*Application for Amendment of USNRC Source Materials
License SUA-1601,
Ross ISR Project, Kendrick Expansion Area*

*RAI Question and Answer Responses for the
Kendrick Expansion Area Technical Report
Docket #40-09091*

Prepared by:
Strata Energy, Inc.
2929 New Haven Road
Oshoto, WY 82721

November 2016

KENDRICK EXPANSION AREA
TR RAI RESPONSE
FIGURE TR RAI 2.6-1-1
PERIMETER MONITOR WELL RINGS,
DM TRANSITION LINE, LOCATIONS OF
GEOLOGIC CROSS SECTIONS AND
ISOPACH OF CONFINING LAYER
BELOW ORE ZONE

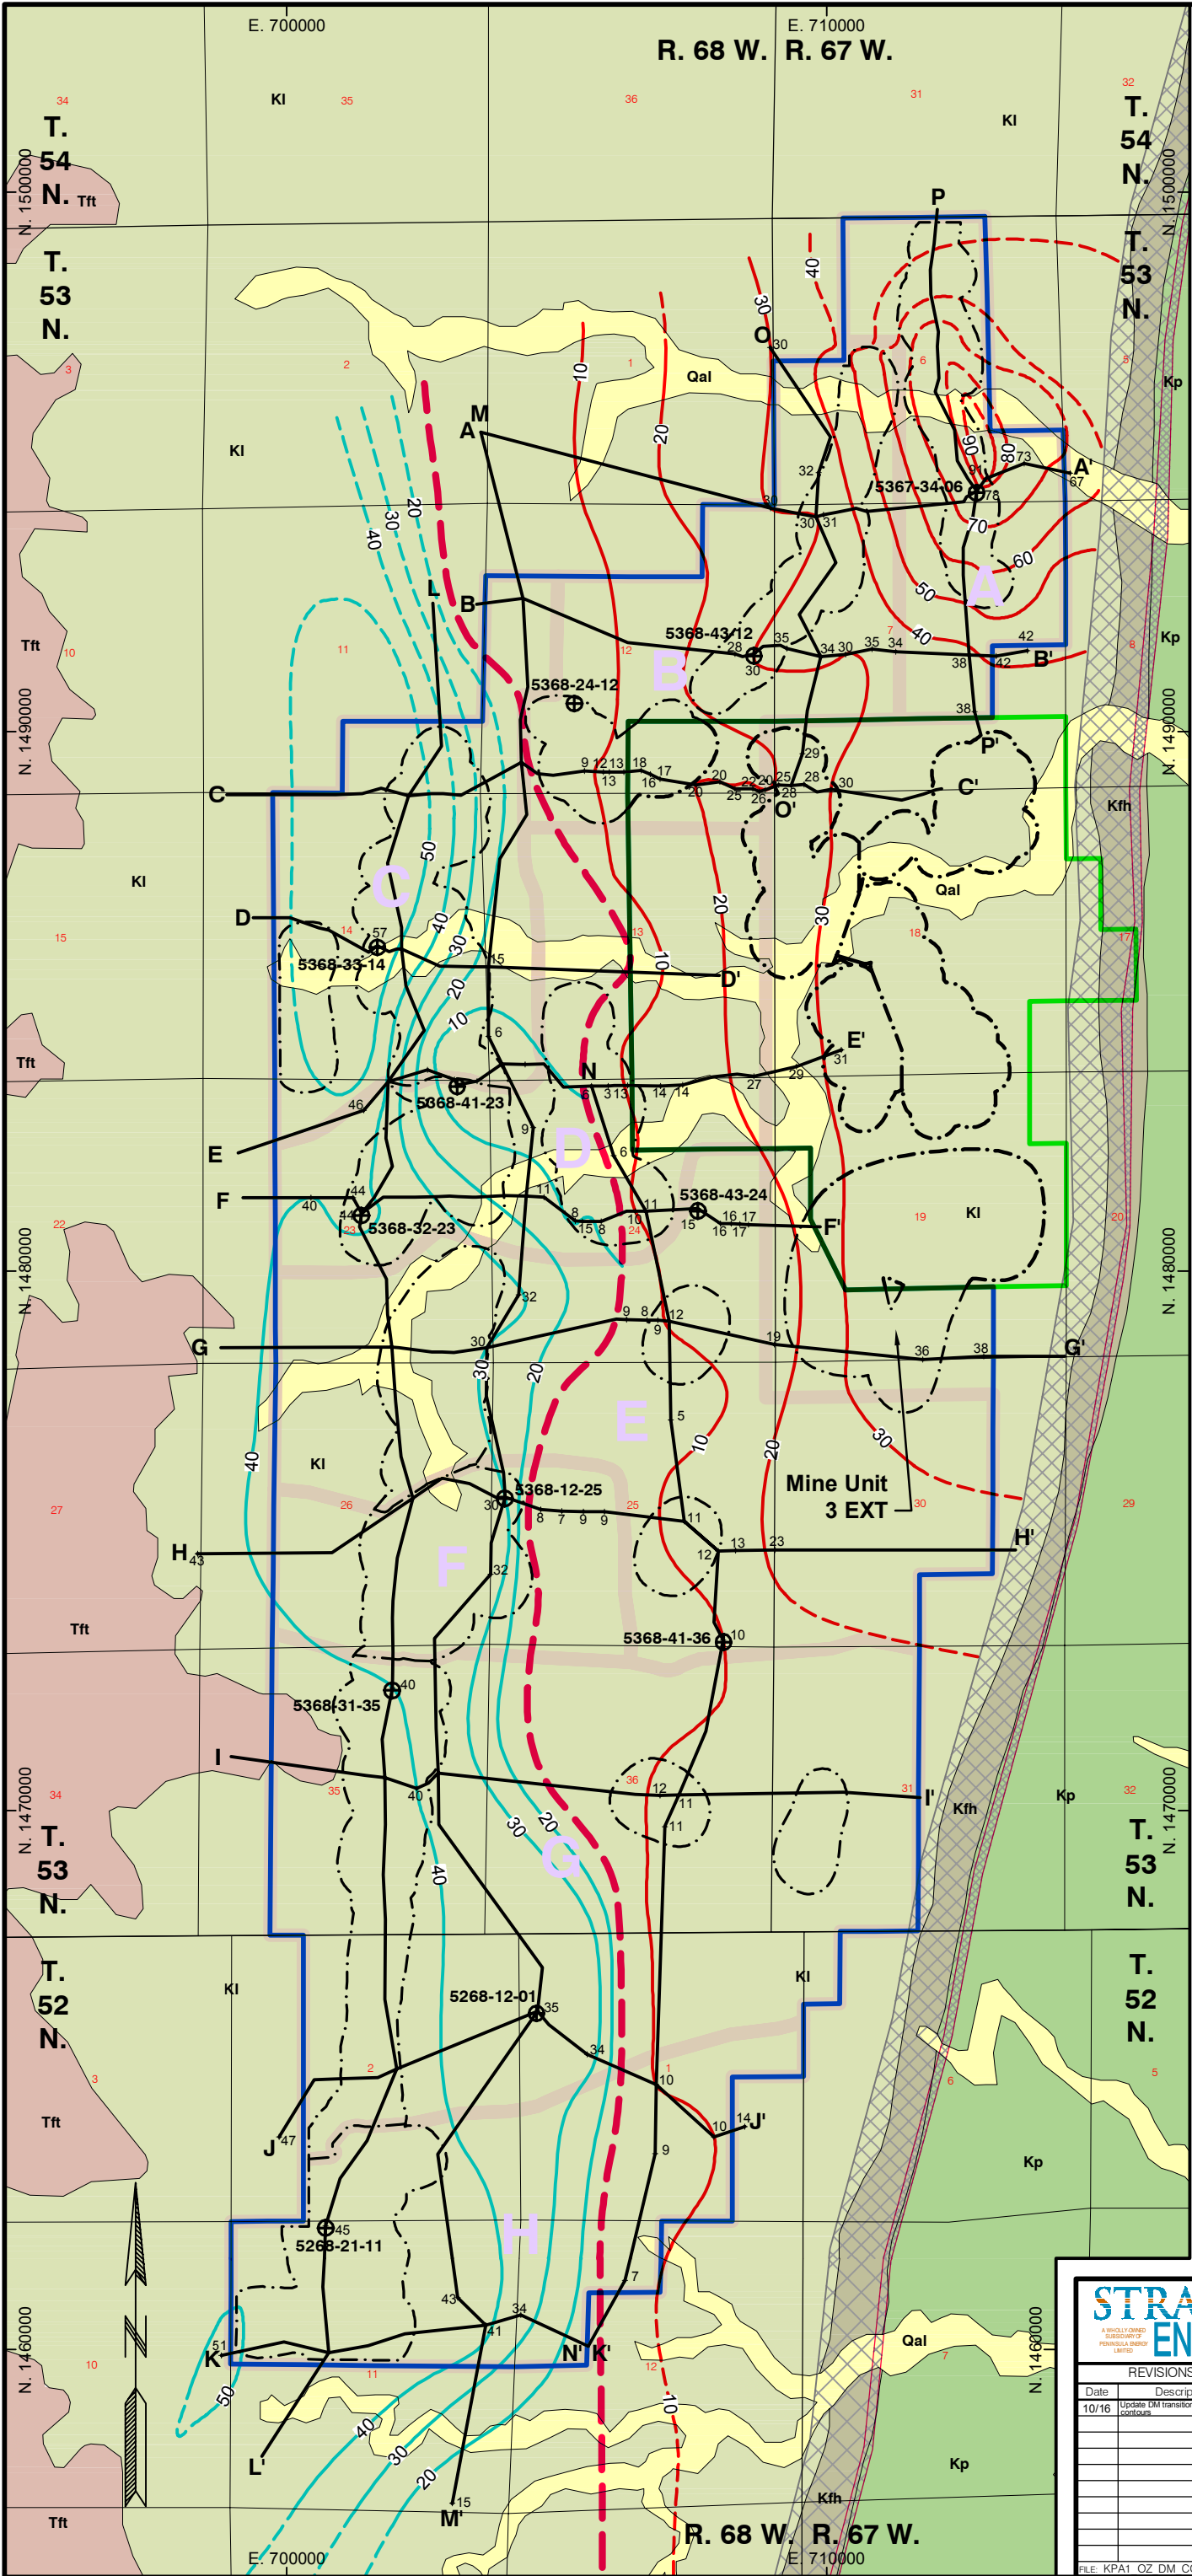
Please revise the geologic cross sections (Addendum 2.6-A) and isopach and structural mapping (Addendum 2.6-B) to verify that the DM and underlying confining units are present throughout the Kendrick area.

Figure TR RAI 2.6-1-1 depicts the approximate perimeter monitor well ring extents, line of coalescence (DM transition line) and locations of the KEA geologic cross sections. As background, in both the Mine Unit 1 and Mine Unit 2 wellfield data packages, Strata characterized the subsurface geology out to and often beyond the perimeter monitor well rings. This information, along with the addition of the planned mine unit extents to the cross sections, should allow the staff to better understand the level of information provided regarding the DM and underlying confining interval(s) in KEA mine unit areas. In addition to incorporating the planned mine unit extents into the revised cross sections, Strata also revisited several geophysical logs that were used to construct the cross sections, including revising the DM intercepts on two logs and picking previously unmarked DM intercepts on four logs. The revised logs appear on cross sections A-A' (log SP 210R), B-B' (logs SPD 341M and SPD 342M), C-C' (logs RMR 1488 and RMR 1487), and J-J' (log SP 456R). The revised intercepts more accurately reflect the thickness of the underlying confining layer on the updated cross sections. Revised isopach contours for the BFH1 and BFH2 intervals are provided on Figure TR RAI 2.6-1-1. As stated previously, the number of logs penetrating to the DM interval is consistent between the Ross and KEA cross sections. Based on the updated KEA cross sections, 158 geophysical logs are within planned KEA perimeter monitor well rings. Of these, 29% or 46 drill holes penetrate to the DM interval. This is consistent with the proportion of drill holes penetrating to the DM interval in the approved Ross TR. For example, cross section A-A' in Addendum 2.6-C of the Ross TR included 149 geophysical logs, of which 47 or 32% penetrated to the DM interval (BFS 2 sand). Considering the above information, Strata believes that the characterization of the underlying confining interval both across the KEA and, more importantly, within future mining areas is sufficient.

transition line), an isopach map of the DM interval (Figure 3, which includes both BFS sands) and, most importantly with respect to confinement, an isopach map of the BFH 1 and BFH 2 confining interval(s) (Figure 4). Providing structure contour and isopach maps of the DM interval was beyond standard industry practice and guidance in SRP, Section 2.6.1, which suggests isopachs should be provided “of the mineralized strata and of the confining layers” but not underlying monitoring intervals. These maps were provided to aid in NRC staff review of the underlying confinement and characterization of the underlying water-bearing interval. Both the structure contour and isopach maps, depict continuous underlying water bearing intervals in both the BFS 1 and BFS 2 as well as the underlying confinement provided by the BFH 1 and BFH 2 shale layers. Data sources are indicated on the figures in Note 2, which states, “Surfaces shown derived from geologic cross sections using Rockworks® software.” To further aid in staff review and beyond what was done in the approved Ross TR, the isopach of the underlying confining layer was updated and simplified to depict the thickness of the underlying confining unit at each geophysical log. Updated isopach contours included on Figure TR RAI 2.6-1-1. This figure depicts the revised isopach contours of the underlying confining interval, the data points used to develop the contours, a revised DM transition line based on the revised cross sections, and planned perimeter monitor well rings. The isopach was developed using 108 drill holes, of which 46 are within planned perimeter monitor well rings. Thus, Figure TR RAI 2.6-1-1 provides the locations of the data used for interpretation purposes and, more importantly, data within each of the planned KEA mine units.

Strata will replace the geologic cross sections and isopach map in the KEA TR with those included as part of this response package, pending acceptance of the responses by NRC staff. The structure contour maps of the top of the DM (KEA TR Addendum 2.6-B, Figure 1) and bottom of the DM (KEA TR Addendum 2.6-B, Figure 2) were not revised as part of this response, since these simply confirm the direction of dip and presence of the strata within the KEA. Similarly, the isopach of the DM (KEA TR Addendum 2.6-B, Figure 3) was not modified as part of this response, since the focus for the RAI was the underlying confining interval, as discussed during the public meeting with Strata held

Figure TR RAI 2.9-2-1 Sediment Sampling Locations.

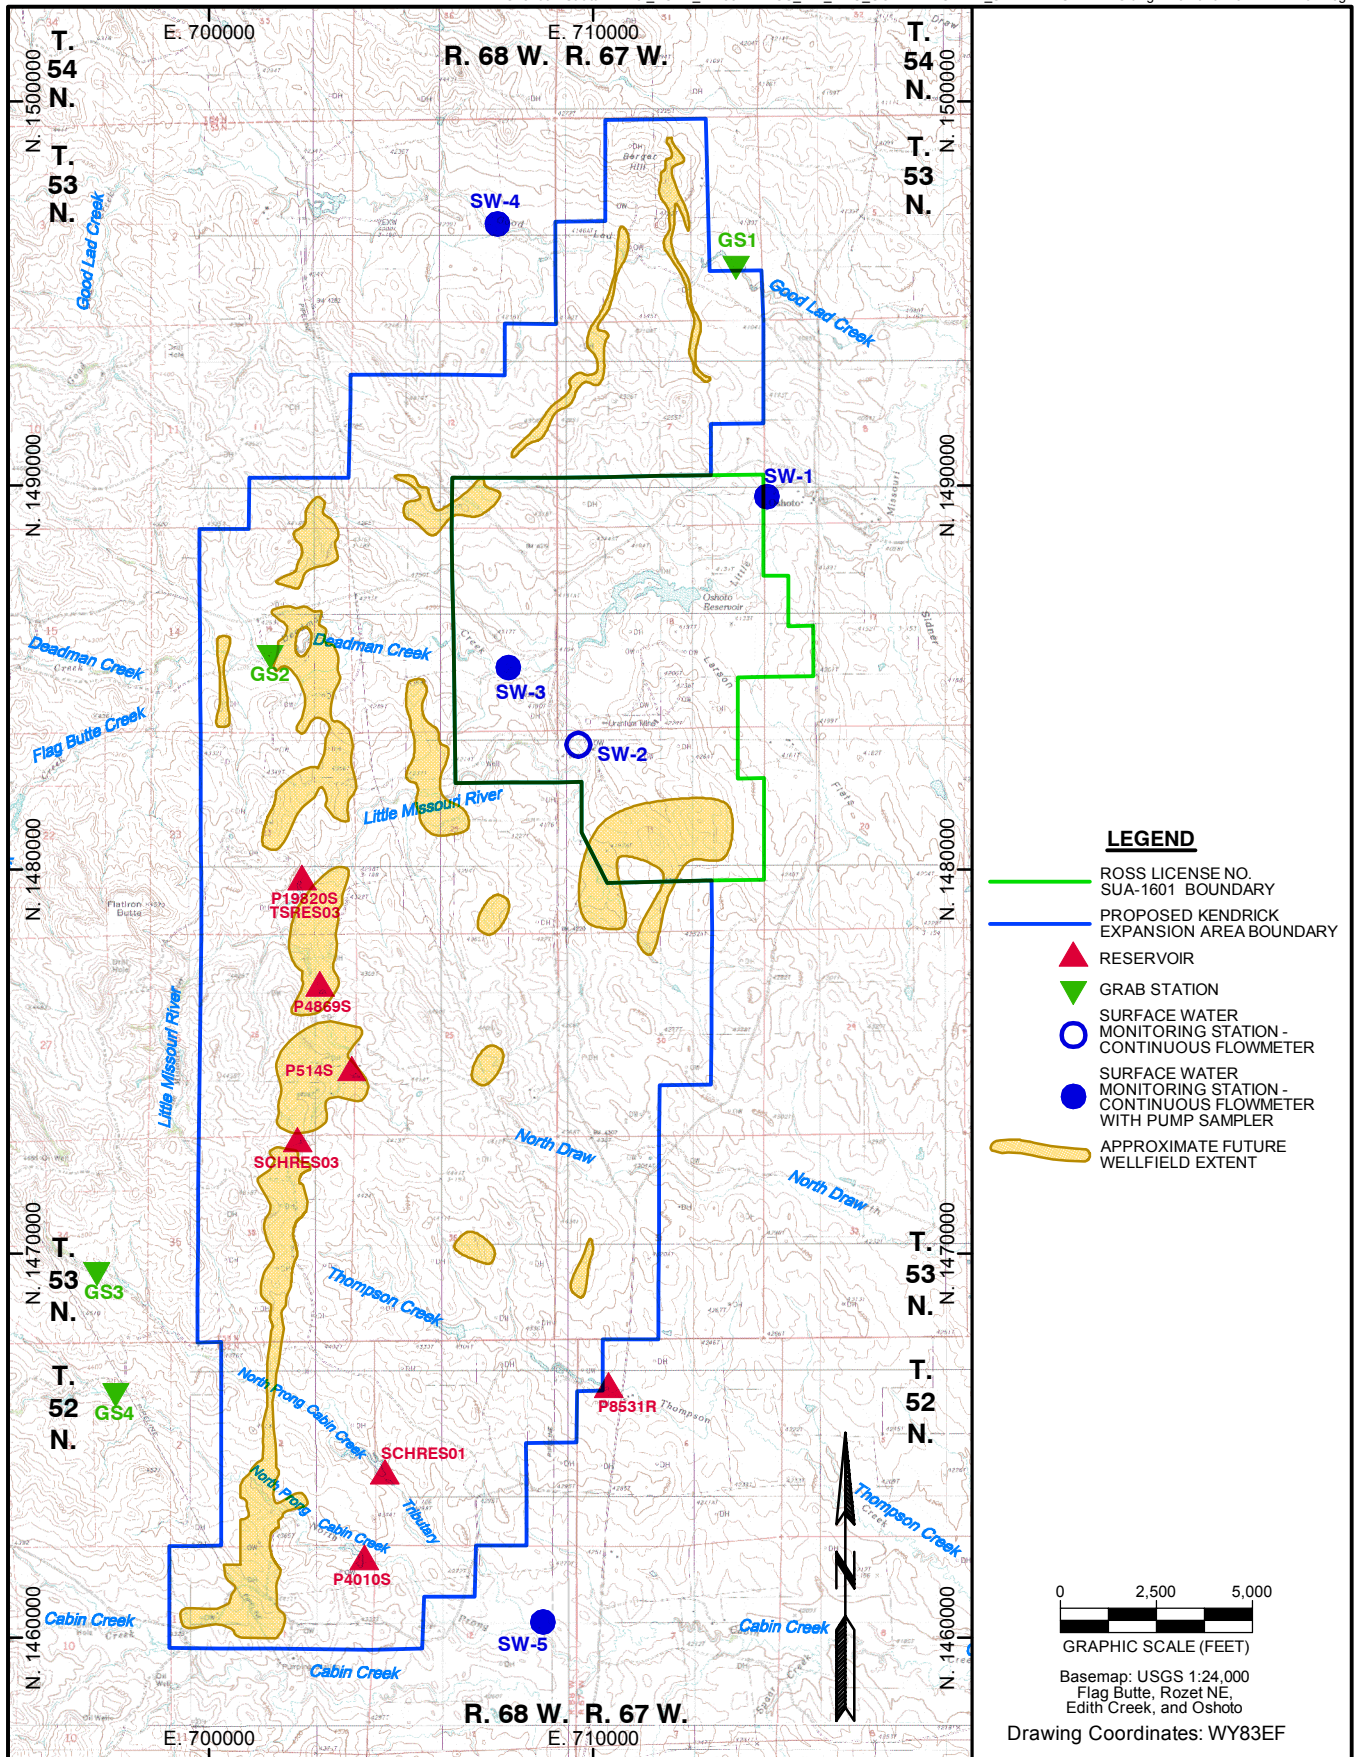
Please provide additional justification for collecting sediment samples only in the late summer, when water levels are expected to be lower than average, and not collecting sediment samples following spring runoff, when water levels are expected to be higher than average.

(including three within reservoirs and one in an ephemeral stream channel), and seven reservoir sites. Table TR RAI 2.9-2-1 summarizes the sediment sampling locations in relation to KEA wellfields. The table indicates the type of site (ephemeral stream channel or reservoir), the location of the site relative to planned facilities (i.e., ephemeral stream channel upstream or downstream of KEA wellfields or a reservoir with potential to be subject to direct runoff from KEA wellfields), and the number of baseline sediment samples collected. Figure TR RAI 2.9-2-1 depicts the baseline sediment sample locations in relation to KEA wellfields.

The reservoir sites were selected based on their potential to be directly impacted by surface runoff from KEA wellfields. Figure TR RAI 2.9-2-1 depicts the reservoir sampling sites in relation to the approximate wellfield extents. If more than one reservoir was located on the same drainage, the most downstream reservoir was selected for sediment sampling.

Figure TR RAI 2.9-3-1. KEA and Ross Operational Air Monitoring Network.

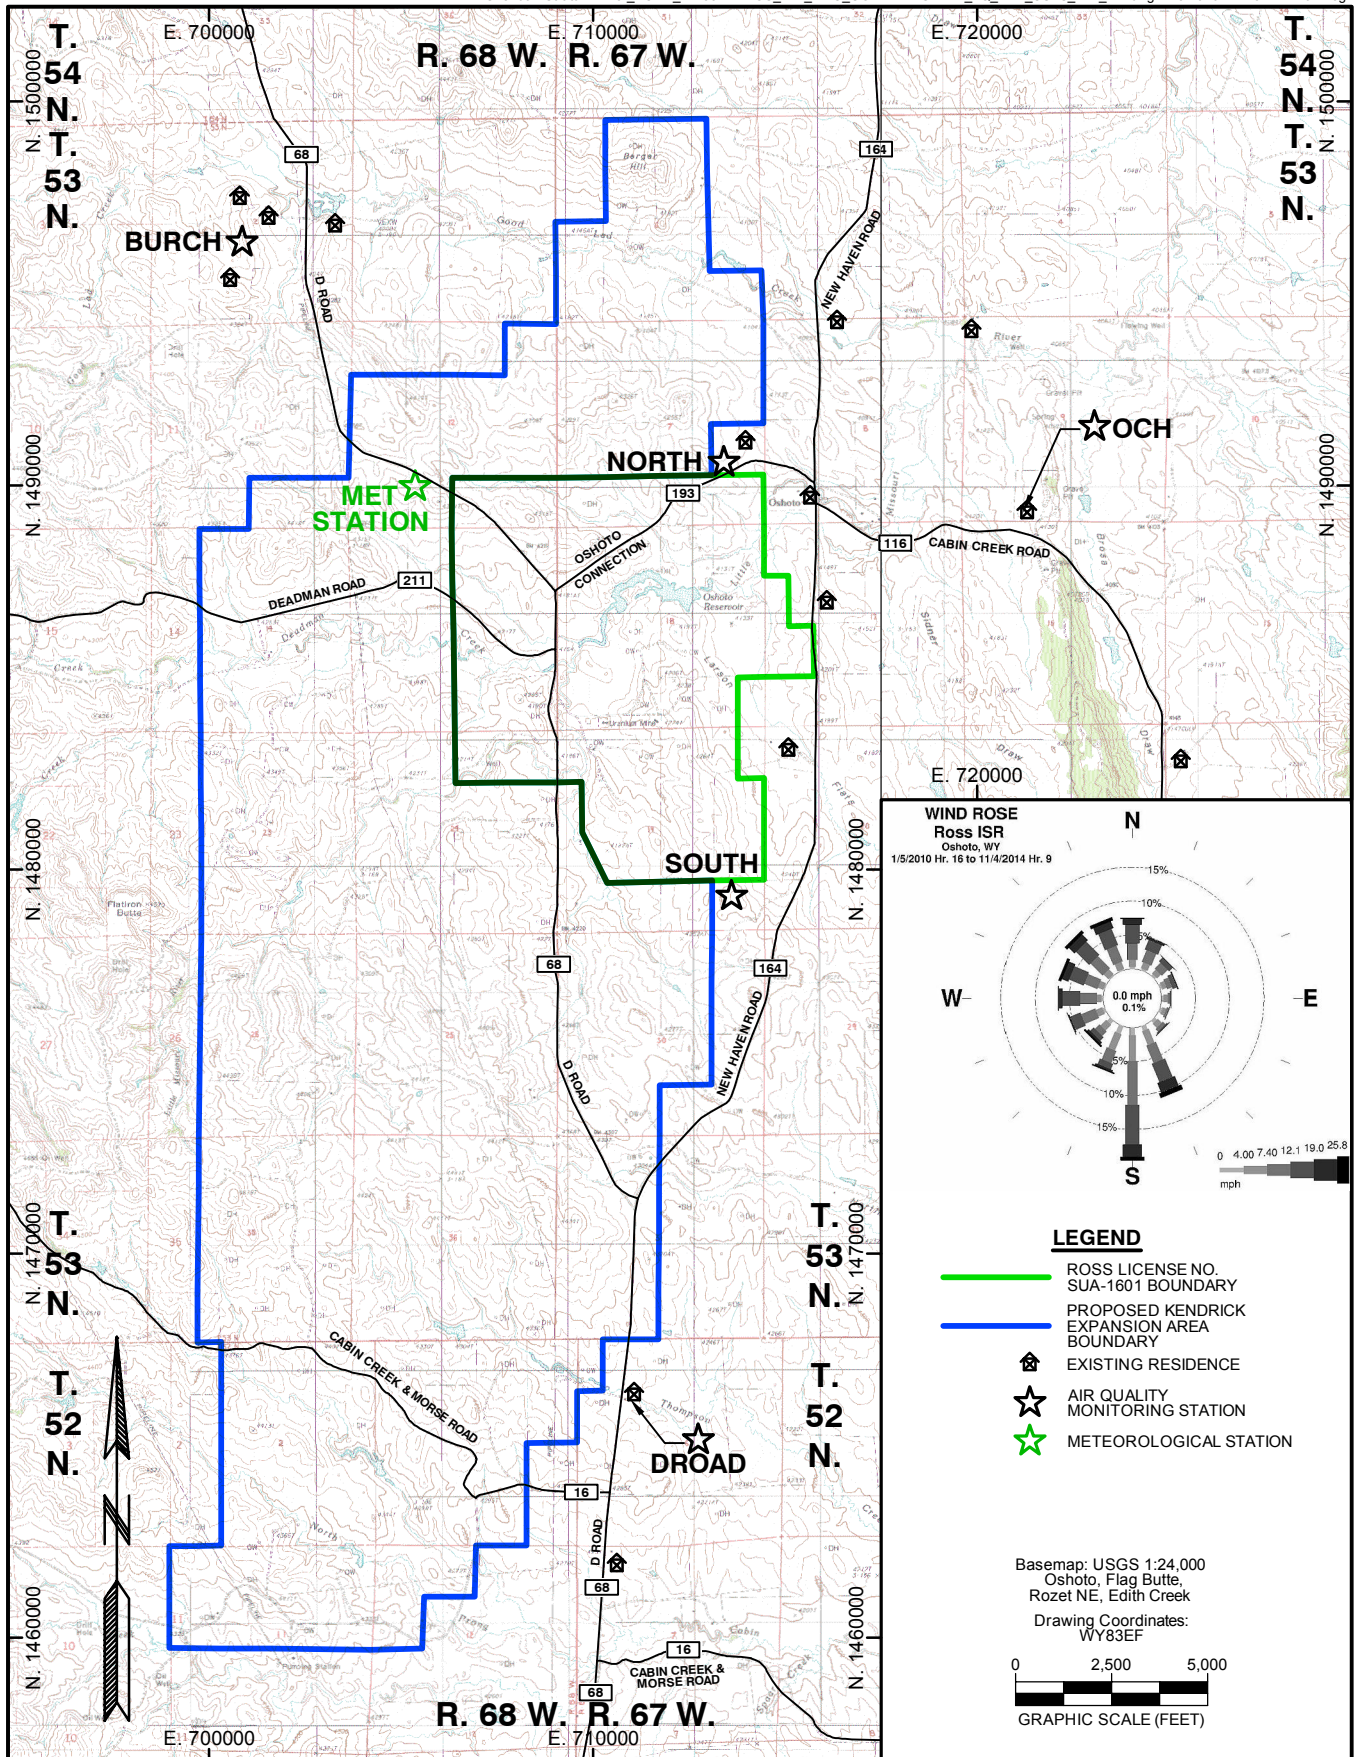
NUREG-1569 Acceptance Criterion 2.9.3 (1) states “Monitoring programs to establish background radiological characteristics, including sampling frequency, sampling methods, and sampling location and density are established in accordance with pre-operational monitoring guidance provided in Regulatory Guide 4.14, Revision 1, Section 1.1 (NRC, 1980). Air monitoring stations are located in a manner consistent with the principal wind directions reviewed in Section 2.5 of the standard review plan.”

As stated, no overlap exists between the currently approved Ross and proposed KEA operational air monitoring networks. Therefore, Strata proposes an integrated monitoring network that would be used for both the Ross and KEA if the KEA license amendment is approved. The proposed operational air monitoring network is depicted on Figure TR RAI 2.9-3-1 and would consist of the following sites:

Strata believes these locations will provide an adequate air monitoring network for the operational air monitoring program as the locations meet the recommendations of RG 4.14, i.e., a minimum of three locations at or near the site boundary, one control location remote from the site, and one location at or close to the nearest residence with the highest predicted airborne radionuclide concentration from milling operations.
